**Re: Loveland Ready-Mix Concrete, Inc., Dunn Pit, File No. M-2021-059,  
112c Permit Application Third Adequacy Review - Inlet Protection**

**Subject: Dunn Pit (Permit No. M-2021-059), Third adequacy review addressing responses from Telesto Solutions, Inc., 21 March 2022**

# NORTHEAST CORNER OF CELL C3 - ORIGINAL VS. UPDATED GRADING

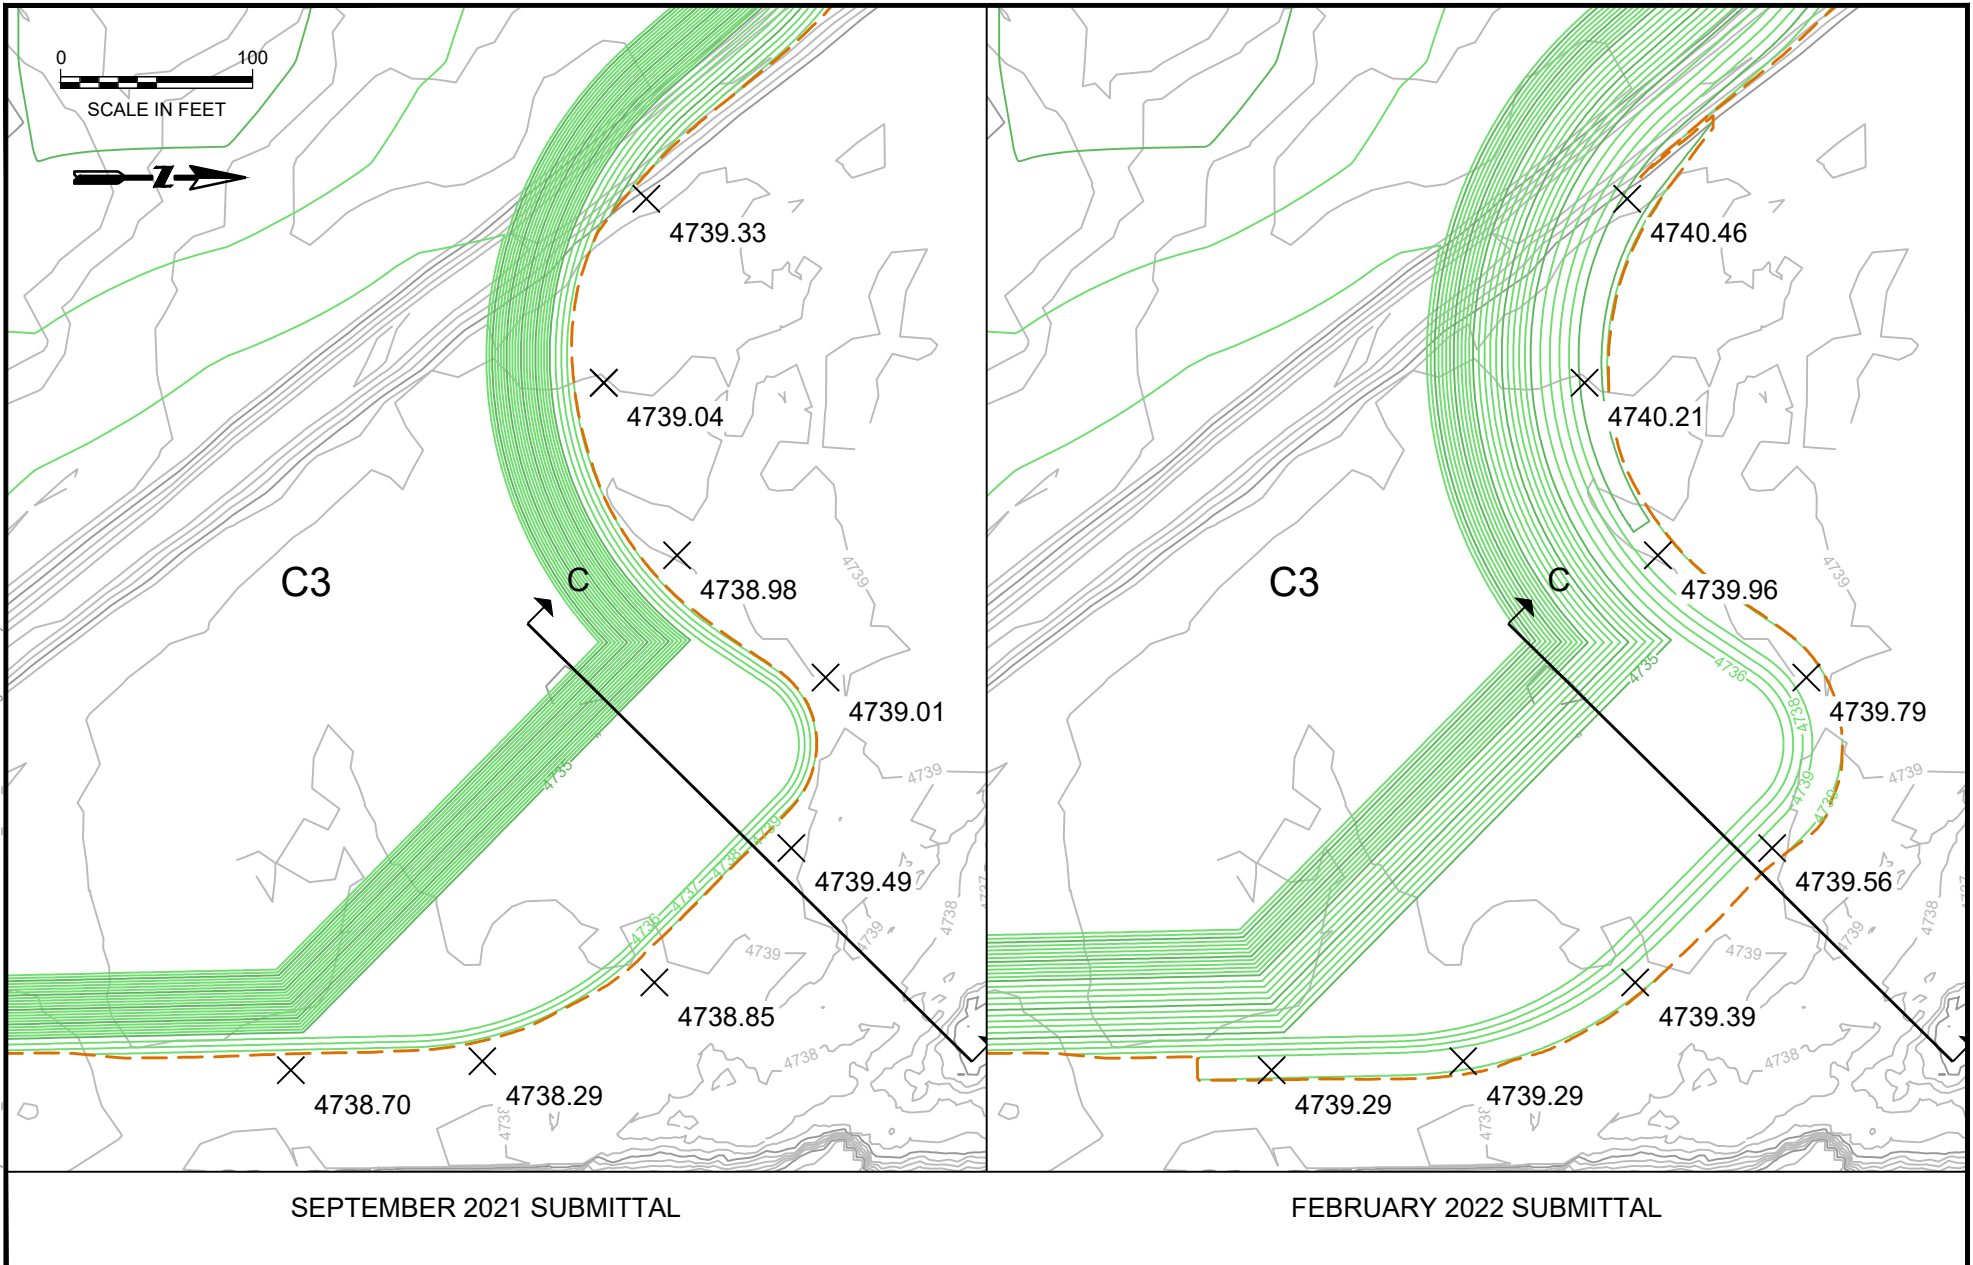
I had a concern related to Comment 6, related to the inlet weir for Cell 3, but email correspondence from Telesto clarified the situation and satisfied my concern. Jon Cullor of Telesto stated that, "... the NE corner of Cell 3 was originally graded to daylight at the elevation of the existing ground surface (no weir; left ½ of the figure). The re-graded Cell 3, as submitted in Feb 2022, included a uniformly graded inlet/outlet weir (right ½ of the figure). The inlet/outlet weir served to remove the low lying undulations in the existing ground surface. Before the addition of the weir, these existing ground undulations allowed water to enter Cell 3 in small amounts at relatively low flow rates."

The figure that Jon refers to is included below.
